# UNITED STATES PATENT AND TRADEMARK OFFICE

APPLICATION NO.	FILING DATE	FIRST NAMED INVENTOR	ATTORNEY DOCKET NO.	CONFIRMATION NO.
10/045,541	10/26/2001	Gerald N. King	0267-001-1436CON	3566

# Office Action Summary

## **DETAILED ACTION**

FIG. 3

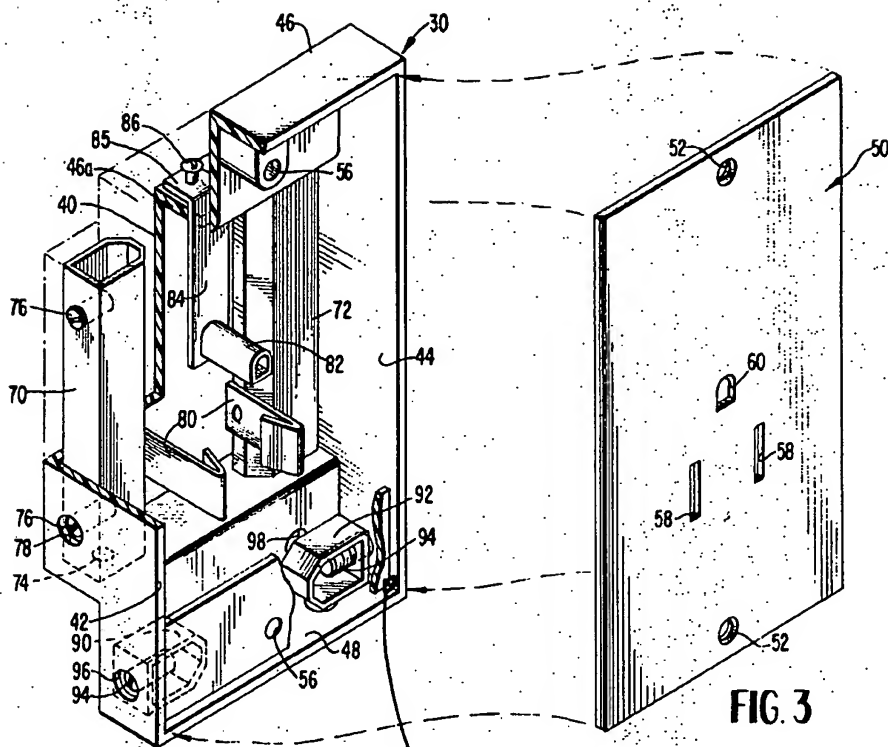
- the base unit [30, figure 1] having a receiving channel [not labeled, see attachment], and a bottom of the removable electrical device [36, figure 1] adapted to nestle within the receiving channel of the base unit.

Applicant argues that the art of record neither discloses nor suggests the structure of a removable electrical device adapted to nestle within a receiving channel of a base unit in combination with a base unit having a channel for receiving an electrical device. Examiner respectfully disagrees. Castellano discloses a base unit [30, figure 1] having a receiving channel [not labeled, see attachment], and a removable electrical device [36, figure 1] adapted to nestle within the receiving channel of the base unit, as applicant newly claimed.

a receiving channel for holding a bottom of a removable electrical device.

FIG. 4

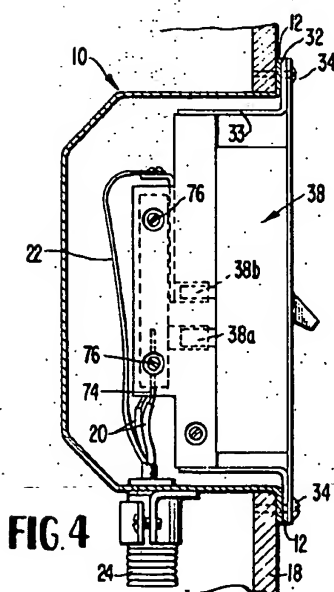
- a mounting trap [33] secured a rear cover of the base [figure 4] to a junction box [10];

FIG. 5

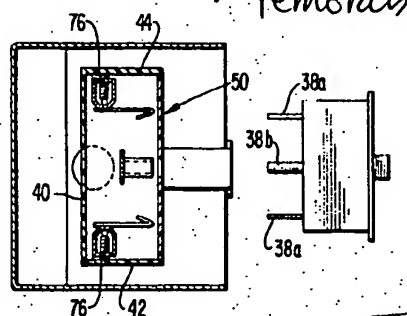
- a base unit [30] having a plurality prongs comprise of first terminal members [80, figure 2] and a plurality of second terminal members [figure 5] with screws [76] connectable to conductors [22] in an electrical wiring system through duct [24];

- a removable electrical device is in form of a receptacle [36, figure 1] or a switch [38, figure 1] having a plurality of power contacts [36a or 38a] and a ground contact [38b] extending through a rear cover of the switch [figures 1 and 5], wherein the power contacts releasably connected to the first terminal members; and
